Standardized Nuclear Unit
Power Plant System

September 9, 1981

SLNRC 81-96 FILE: 0541
SUBJ: RSD Review

Docket Nos. STN 50-482, STN 50-483, and STN 50-486

FIGURE 15.2-15
NUCLEAR POWER, CORE HEAT FLUX AND
TOTAL CORE REACTIVITY TRANSIENTS
FOR MAIN FEEDWATER LINE RUPTURE
WITH OFFSITE POWER AVAILABLE

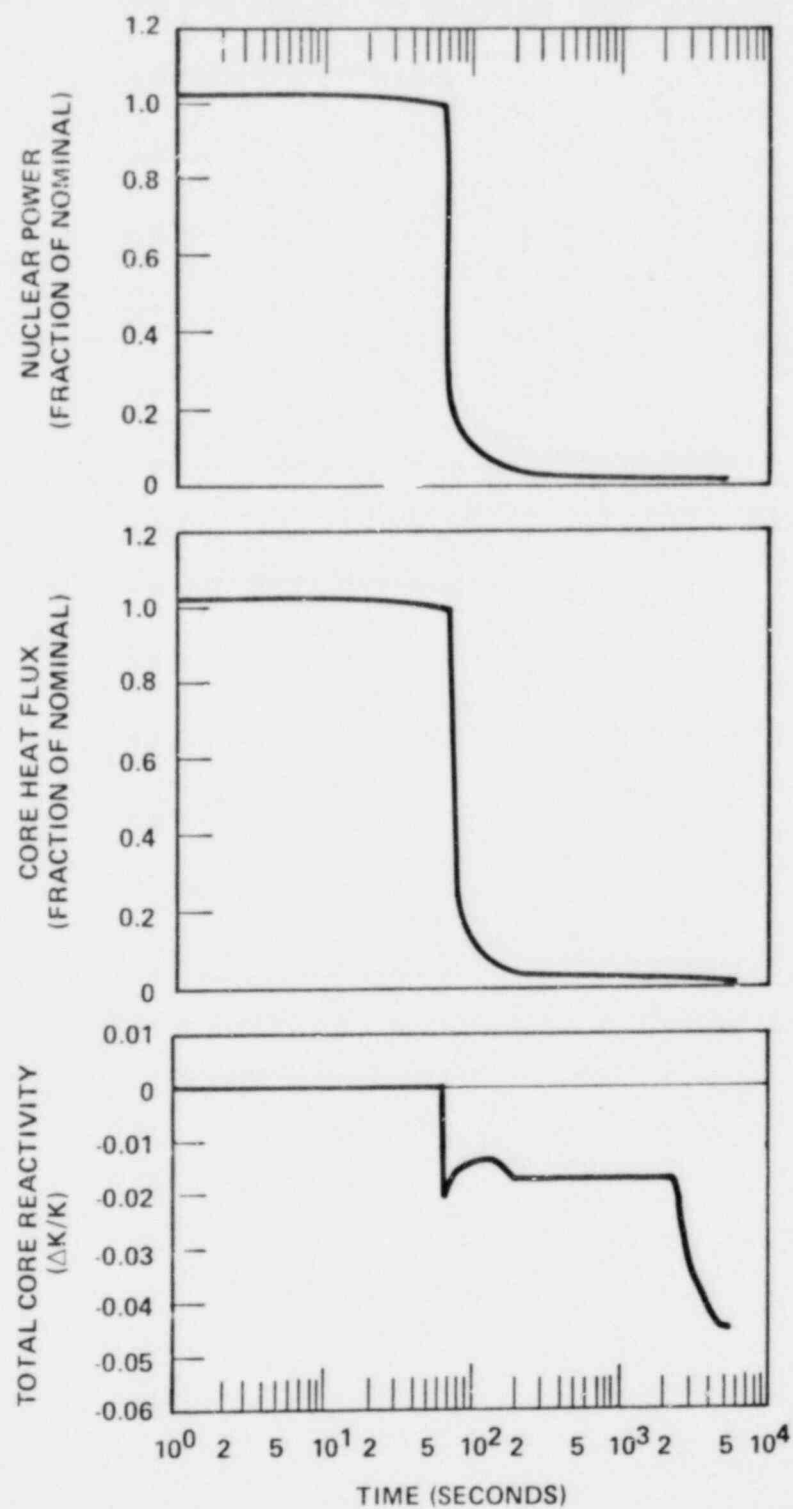
Figures 15.2-15 and 15.2-20 show that following reactor trip the plant remains subcritical.

FIGURE 15.2-16
PRESSURIZER PRESSURE AND WATER
VOLUME TRANSIENTS FOR MAIN FEEDWATER
LINE RUPTURE WITH
OFFSITE POWER AVAILABLE

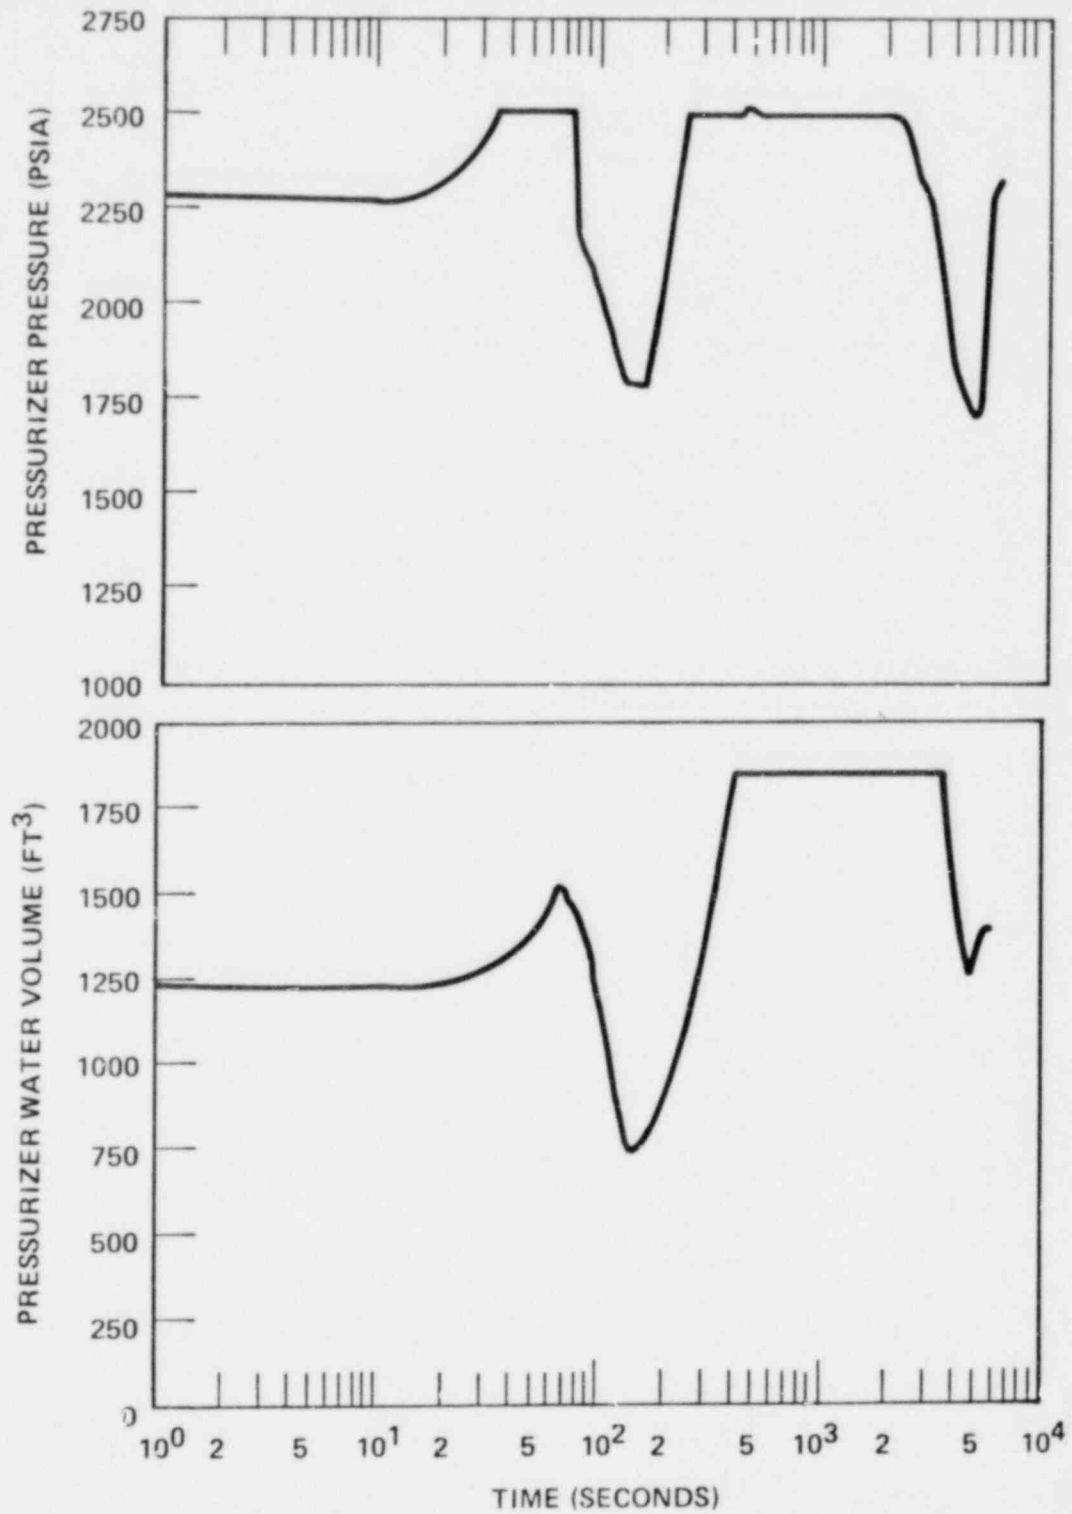
The system response following the feedwater line rupture is similar for both cases analyzed. Results presented in Figures 15.2-16 and 15.2-17 (with offsite power available) and Figures 15.2-21 and 15.2-22 (without offsite power) show that pressures in the RCS and main steam system remain below 110 percent of the respective design pressures. Pressurizer pressure decreases after reactor trip on low-low steam generator level (67.3 seconds). Pressurizer pressure decreases due to the loss of heat input, until the safety injection system is actuated on low steam line pressure in the ruptured loop. Coolant expansion occurs due to reduced heat transfer capability in the steam generators; the pressurizer safety valves open to maintain primary coolant system pressure at an acceptable value. Addition of the safety injection flow aids in cooling down the primary and helps to ensure that sufficient fluid exists to keep the core covered with water.

Figure 15.2-16 shows that the pressurizer does not empty throughout the transient to that the core remains covered at all times and that no boiling occurs in the reactor coolant loops.

FIGURE 15.2-18
 REACTOR COOLANT TEMPERATURE
 TRANSIENT FOR MAIN FEEDWATER LINE
 RUPTURE WITH OFFSITE POWER AVAILABLE

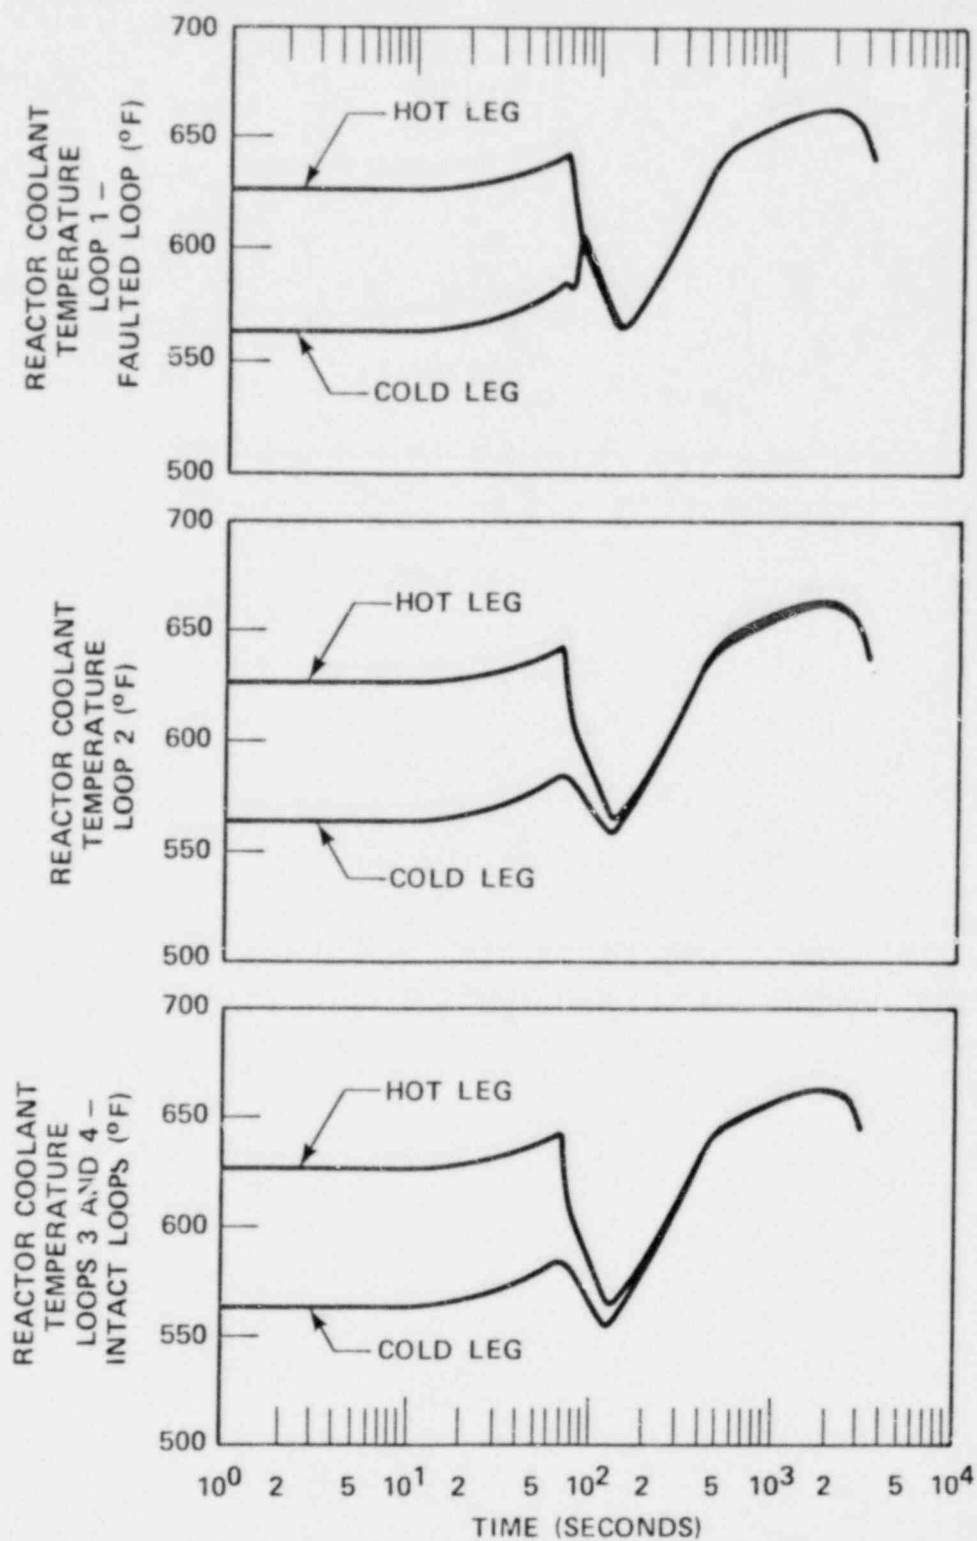
The major difference between the two cases analyzed can be seen in the plots of hot and cold leg temperatures, Figure 15.2-18 (with offsite power available) and Figure 15.2-23 (without offsite power). It is apparent that for the initial transient (~150 seconds), the case without offsite power results in higher temperatures in the hot leg. For longer times, however, the case with offsite power results in a more severe rise in temperature until the auxiliary feedwater system is realigned. The pressurizer fills more rapidly for the case with power due to the increased coolant expansion resulting from the pump heat addition. As previously stated, the core remains covered with water for both cases.

Figure 15.6-3E.
Pressurizer Water Volume Transient
for Steam Generator Tube
Rupture Event

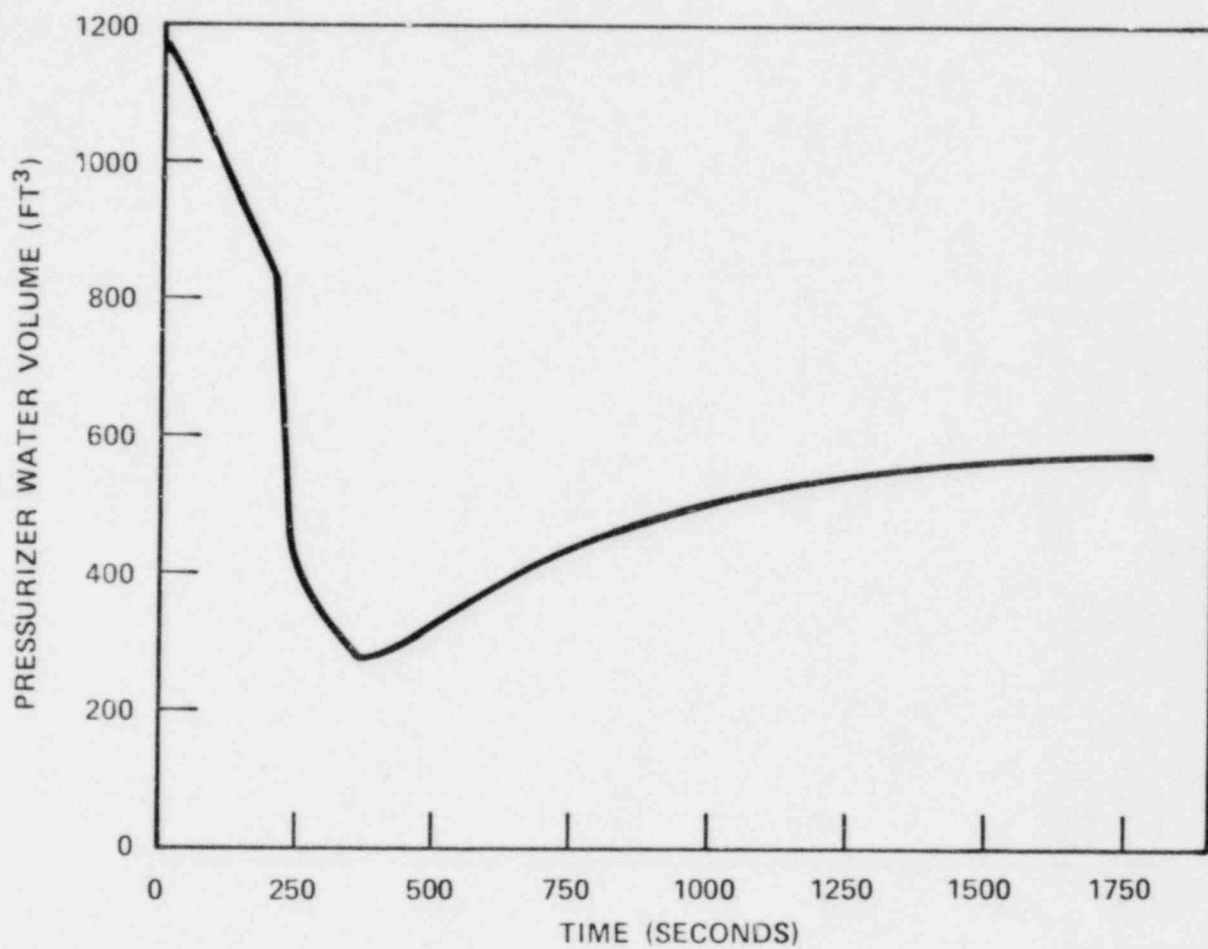
- f. Safety injection flow results in increasing the pressurizer water level (Figure 15.6-3e); the rate of which depends upon the amount of operating auxiliary equipment.
